Service Bulletin

Subject: Intermittent Unwanted Trunk Opening While Vehicle is Parked

Models: 2010-2013 Buick LaCrosse
2011-2013 Buick Regal
2012-2013 Buick Verano
2011-2013 Chevrolet Cruze
2012-2013 Chevrolet Sonic (4 Door Sedan Only)
2013 Chevrolet Malibu

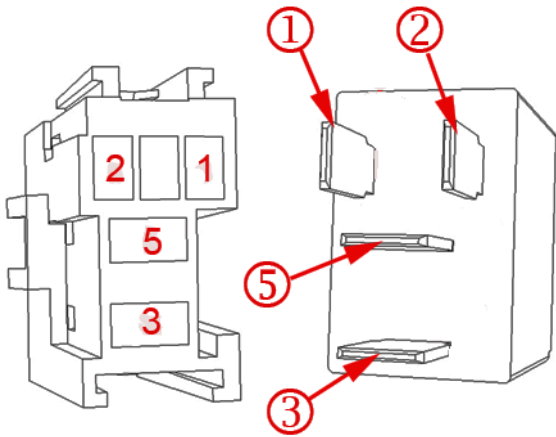
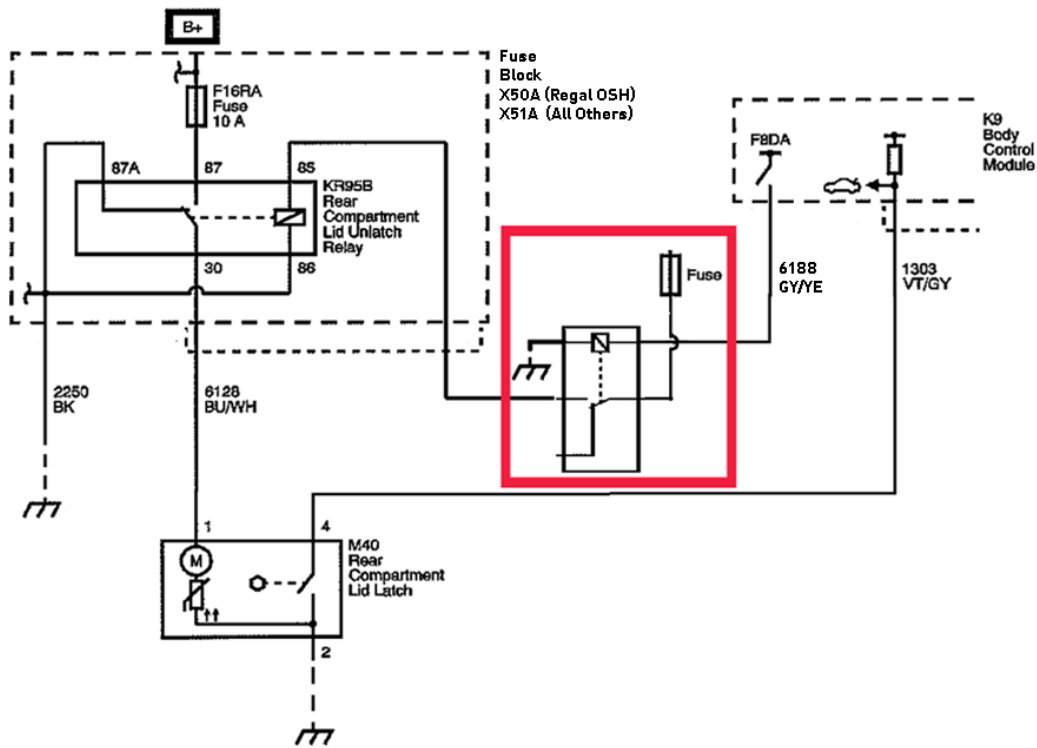
The rear compartment lid unlatch relay is part of the printed circuit board in the relay/fuse block and not serviceable separately. Installation of an external relay circuit to bypass the feed to the trunk release control will be required. Install the "Two Shot Relay" adjacent to the BCM and attach a tag to the relay and mark with "Two Shot Trunk Relay per Bulletin PI0924." For future diagnosis for an inoperative trunk release, this relay installation will be identified before a BCM is replaced.

1. Label the four leads of connector, P/N 12126045 as indicated below.
2. Connect the connector to the new relay, P/N 19119267.
3. Locate circuit 6188 (trunk release control) at the BCM following service information. Cut the wire and splice the BCM and relay side of the circuit as shown below.
4. Connect wire fused, unswitched power and ground as shown below.

1. BCM Circuit No. 6188
2. Ground
3. Relay Circuit No. 6188
5. Fused 12V Power
